Re: 2nd Site Development Plan Review, King Soopers #147 – Falcon Market Place

Please find below our re-submittal package addressing the comments received on May 4, 2020. To facilitate your review, we have included the original comments in italicized font, and have provided our responses in [blue](#).

L1.0

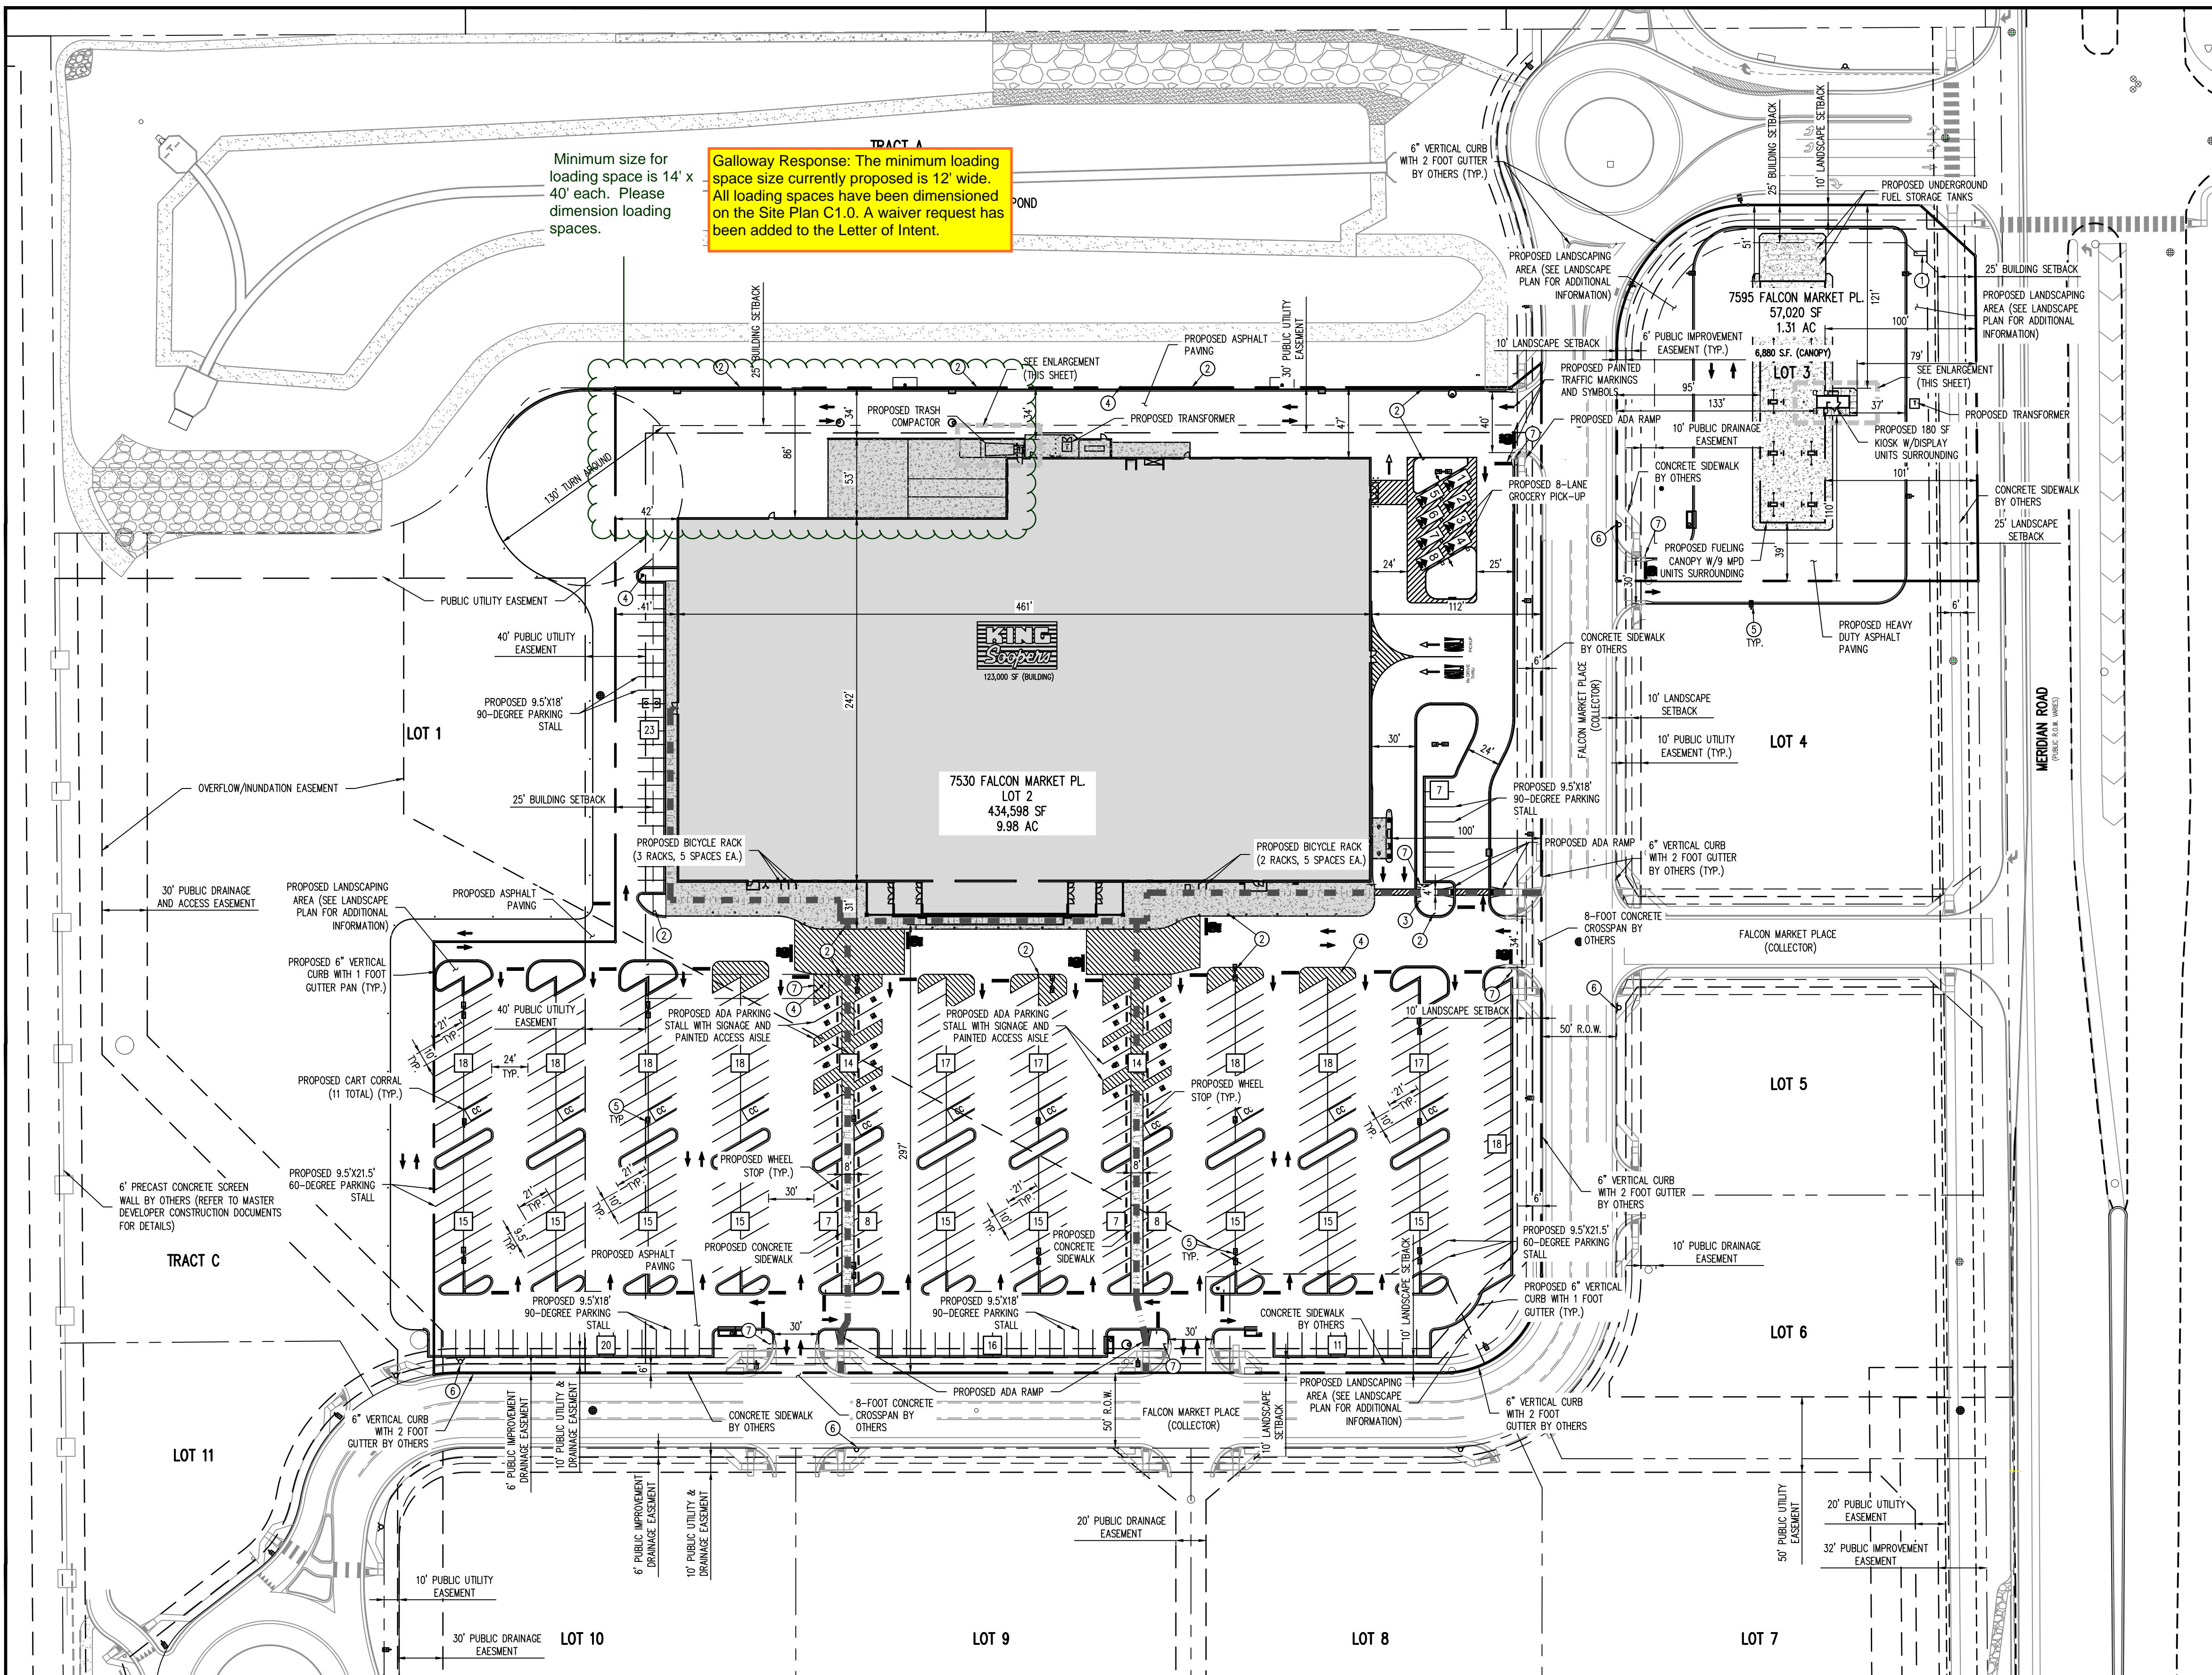
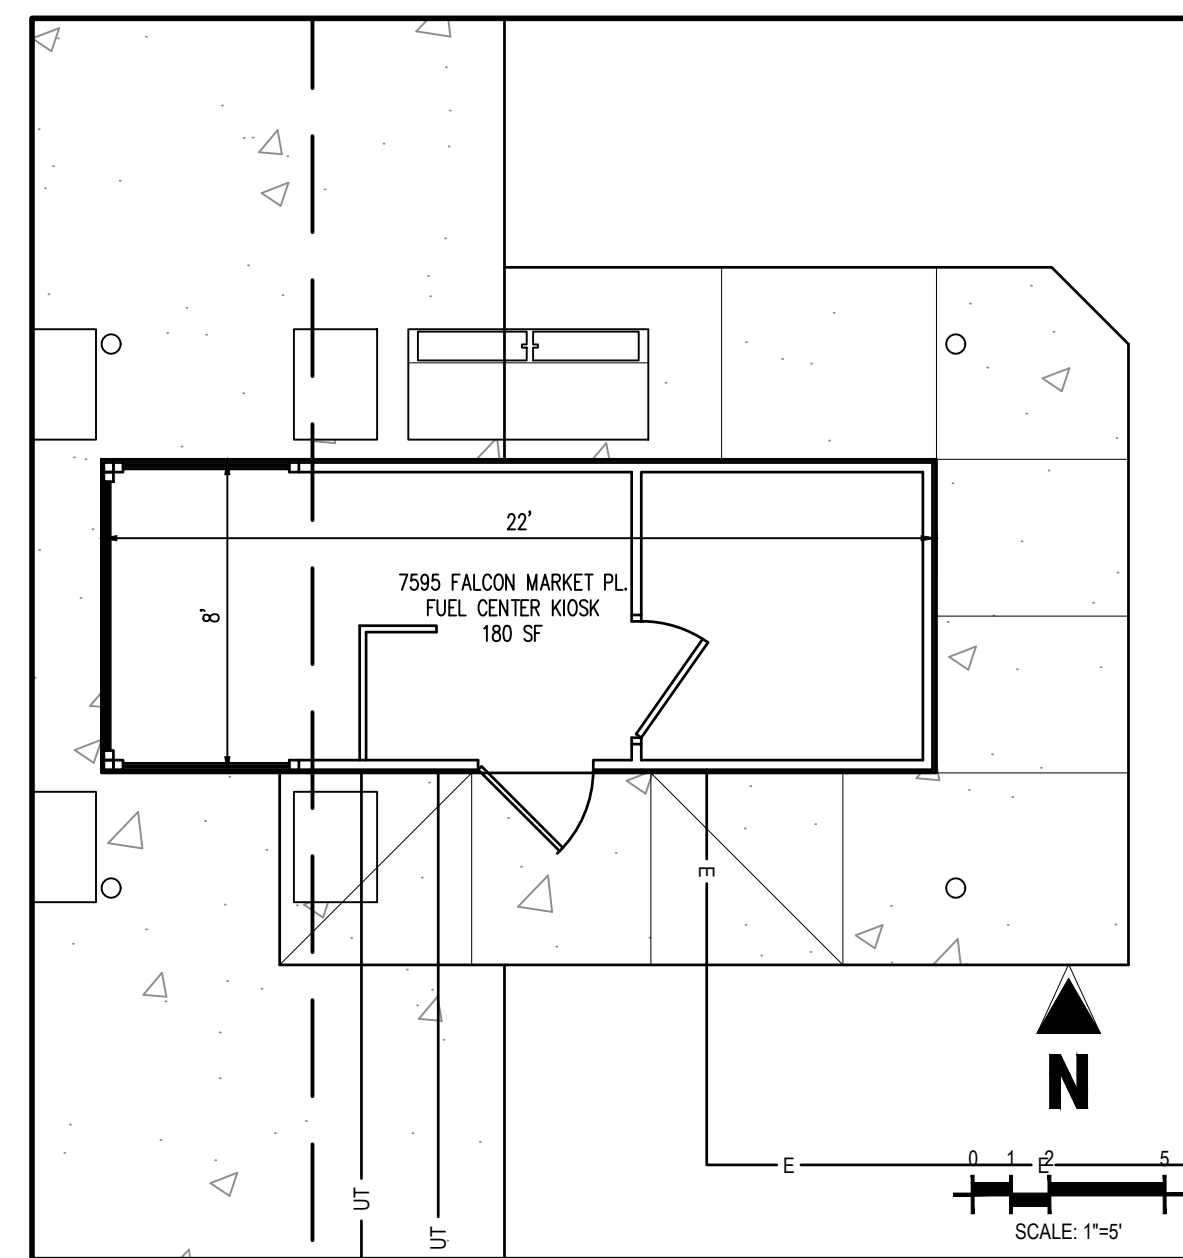
✓ Please ensure consistency with approved landscape plan for Falcon Marketplace plan. Several locations appear inconsistent / deficient with the number of street trees proposed.

Galloway Response: Per conversation with Ryan Howser on 5/21, the number of street trees currently proposed matches the approved plan. This comment can be disregarded.
